## MEMO

**TO:** Scott Cosman, P Eng.  
**COMPANY:** BC MOTI  
**FROM:** Bob Forsyth, P Eng  
**DATE:** 20 December 2024  
**CC:** Zach Crippen, P Eng, Jenna Lee, P Eng.  
**PROJECT NO.:** CA0039758.7070  
**SUBJECT:** Proposed Embankment/Drainage Ditch Slopes, Hwy 9 near Miami Creek, Harrison Hot Springs, BC

Figure 1: Conceptual Plan Sketch of the Wing Wall and Embankment with Mid Slope Butress

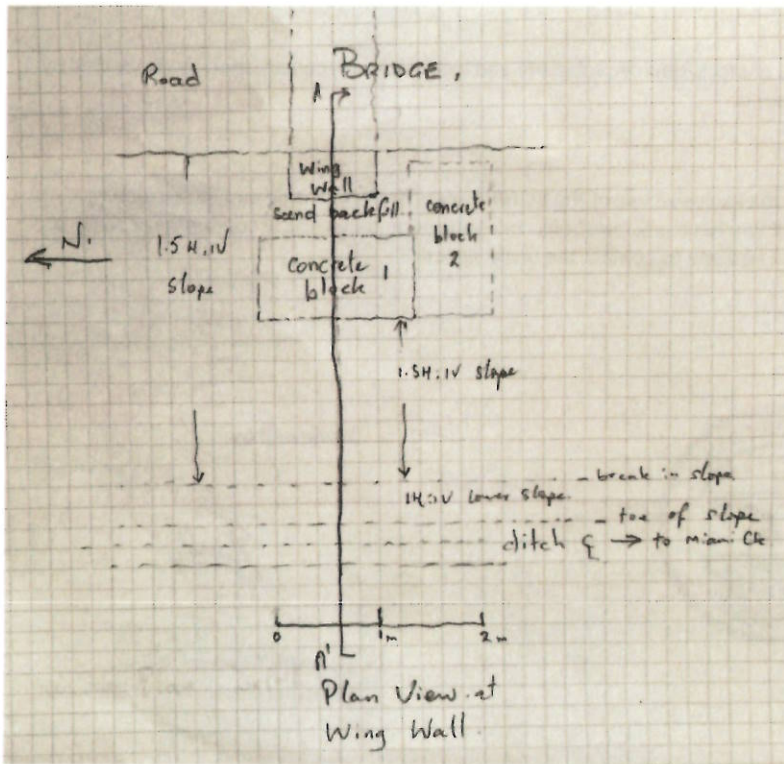
- The lower 0.5m of the embankment slope will be surfaced with small boulders and inclined at about 1H: 1V. The base of the boulder slope should be 0.5m wide
- Above a height of 0.5m, (about elevation 10.8m) the slope will be inclined at 1.5H: 1V and planted with vegetation.
- The elevation of the bottom of the wing wall/pile cap should be determined at the time of construction or earlier if possible. The 1.5H: 1V slope may intersect the face of the wing wall 0.3m or more above the base of the concrete. In this case, the embankment should be sloped at 1.5H: 1V with no remedial action required.
- If this is not the case and there is less than 0.3m of cover above the bottom of the wing wall, remedial action, consisting of a mid slope buttress, could be considered as described below.

- Concrete lock blocks, 1.5m X 0.75m X 0.75m in dimension, should be placed at the mid portion of the slope. There should be a set of blocks oriented lengthwise north to south and another to be placed on the south side of the pile cap oriented lengthwise west to east.

- The base of the lock blocks should be below/behind a 2H: 1V projection from the toe of the slope.
- The lock blocks should be placed on compacted granular fill, inclined so that the lock blocks will have a battered face inclination of 1H: 10V or flatter. We envisage that the lock block wall will be two blocks high.

- We envisage that the back of the lock blocks will be at least 300mm from the wing wall. The blocks will be backfilled with clean sand and gravel. The backfill should cover the lower 0.3m of the pile cap and not extend above the halfway point of the upper block.

Figure 2: Conceptual Profile View with mid slope butress

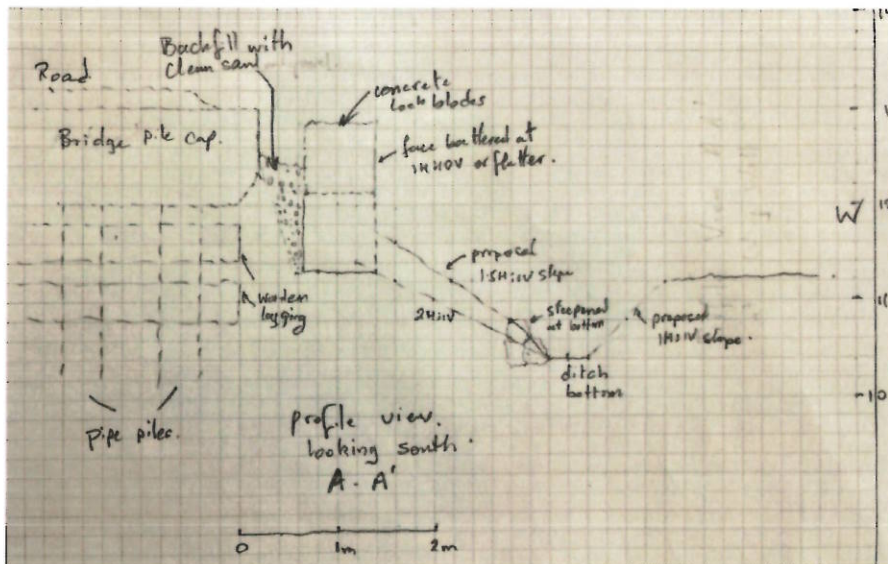
- If desired, the buttress could consist of angular boulders instead of concrete lock blocks. Such are typically constructed by an experienced excavator operator. The boulders are typically fitted together so that they are well interlocked. The batter angle is typically about 1H: 2V. The boulder supplier should provide test results showing that the boulders are not subject to metal leaching or acid rock drainage.
